**Subject: Voluntary Investigation and Remediation Plan  
BWAY Drum Site (HSI #10731)  
1601 Valdosta Highway, Tax Parcel No. 063-026  
Homerville, Clinch County, Georgia**

**Voluntary Investigation and  
Remediation Plan  
BWAY Drum Site  
Homerville, Georgia  
HSI Site No. 10731**

**Subject: Additional Response to EPD 8/23/10 Correspondence  
Regarding the VRP Application for  
BWAY Drum Site (HSI #10731)  
1601 Valdosta Highway, Tax Parcel No. 063-026  
Homerville, Clinch County, Georgia**

**RECEPTOR MAP**  
VOLUNTARY REMEDIATION PLAN - REVISION 1  
BWAY CORPORATION (HSI # 10731)  
HOMERVILLE, CLINCH COUNTY, GEORGIA

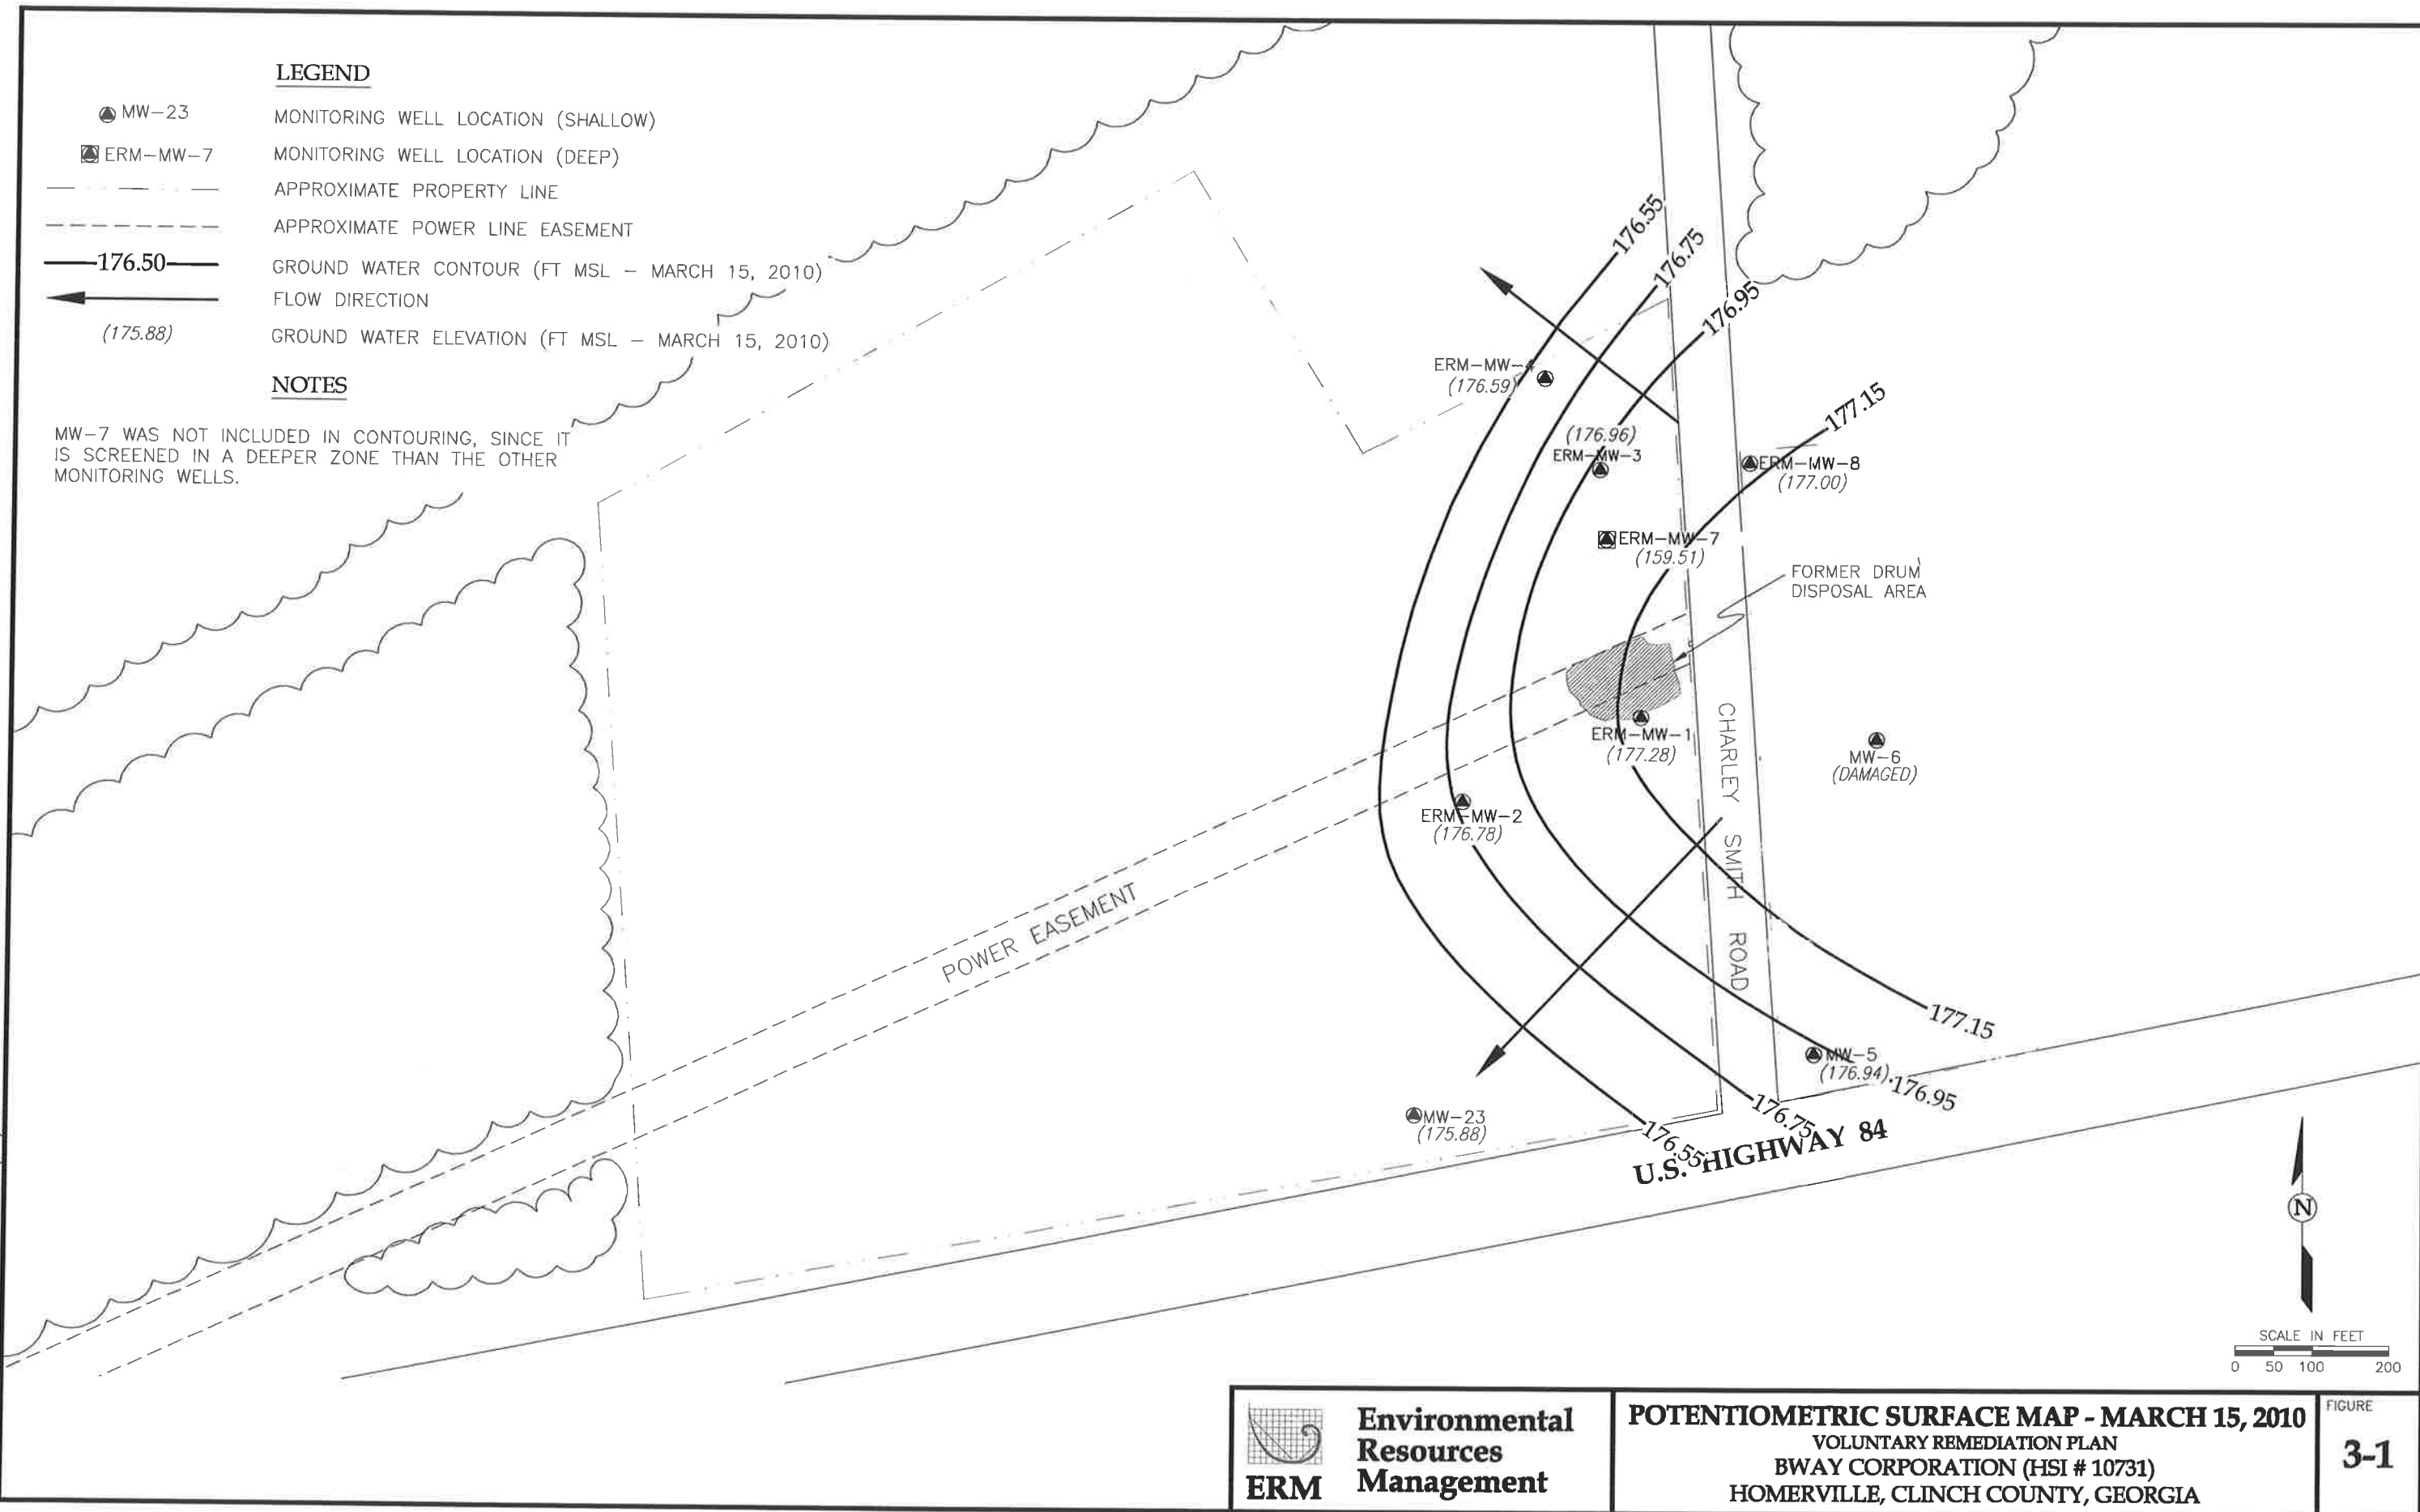
- b. Surface Water/Ecological: Section 1.4 and Figure 1-3 of the VRP indicate there are no surface water bodies located within the area occupied by the ground water plume or in the downgradient direction. However, based on a review of the portion of the USGS topographic quadrangle map provided as Figure 1-1 and online Digital National Wetlands Inventory Maps maintained by the US Fish and Wildlife Service, the following surface water bodies may also be located within 1,000 ft. downgradient of the onsite contaminant plume and its sources: 1) creeks and wetlands located on and to the northwest of the qualifying property; and 2) Bateman's Pond located on the property immediately south of the qualifying property. Please note that although historical maximum concentrations of regulated substances listed on Table 1-1 in groundwater at the qualifying property are less than Georgia In-Stream Water Quality Standards, the referenced surface water bodies cannot be eliminated as potential POEs until comments regarding groundwater contaminant delineation and fate and transport modeling are adequately addressed.

***Response: This comment was addressed in Section 4.4, Figure 1.3, and Figure 1.4 of the January 25, 2011 Voluntary Investigation and Remediation Plan.***

**CROSS-SECTION B-B' (DELINEATION)**  
VOLUNTARY REMEDIATION PLAN  
BWAY CORPORATION (HSI # 10731)  
HOMERVILLE, CLINCH COUNTY, GEORGIA

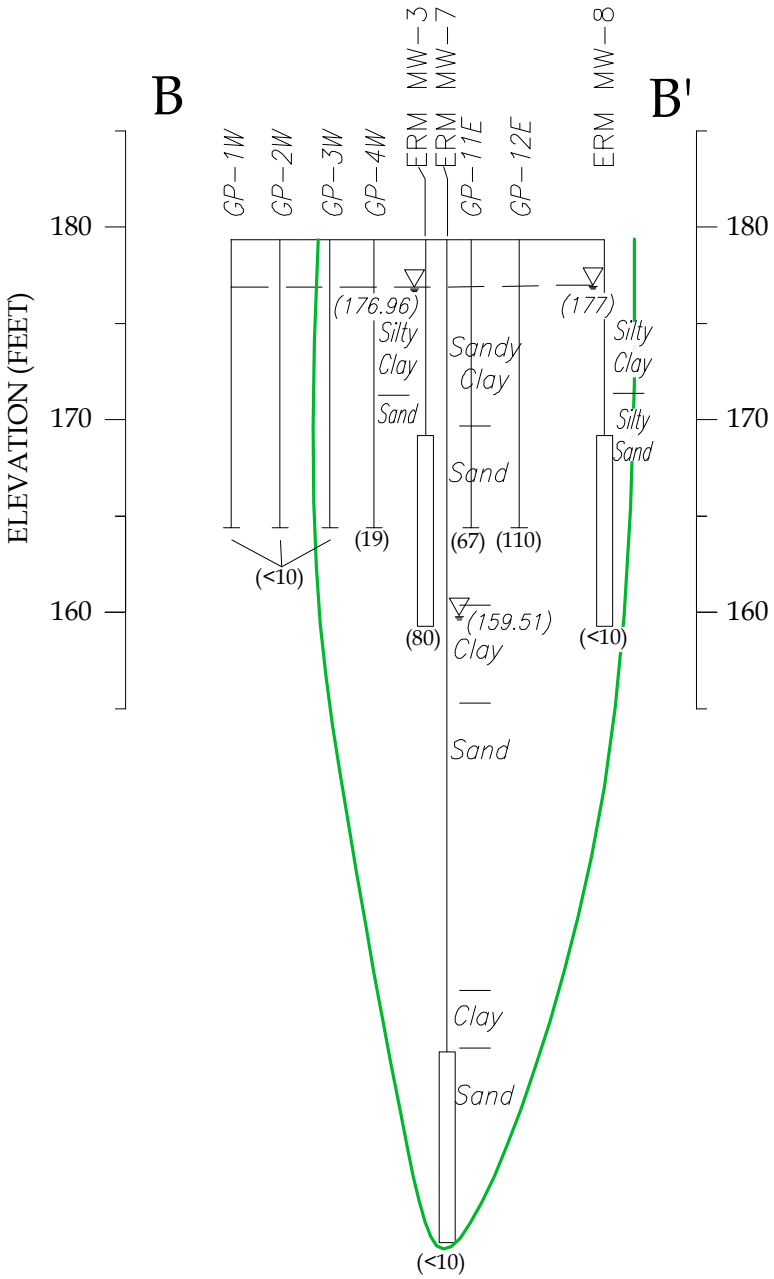
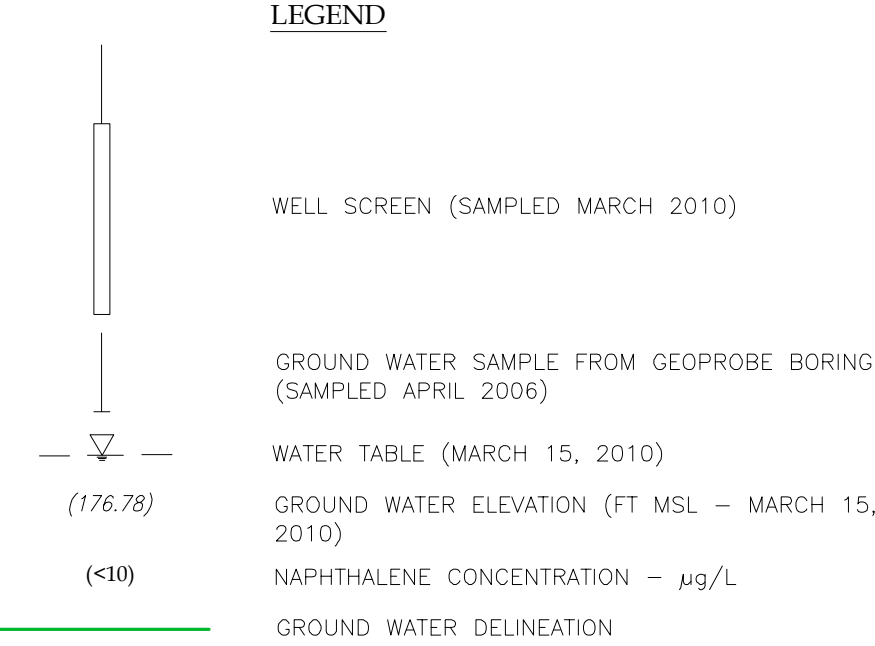
- c. The location of Cross Section D to D', Figure 3-4 of the VRP, is not appropriate for demonstrating the current status/extent of the groundwater contaminant plume since it is located outside the area of the plume. Cross sections should include the central portion of the plume using the monitoring well demonstrating the highest contaminant levels in groundwater as a data point. In addition, monitoring wells installed to address plume delineation deficiencies addressed in Comment 4 should be incorporated into revised cross-sections.
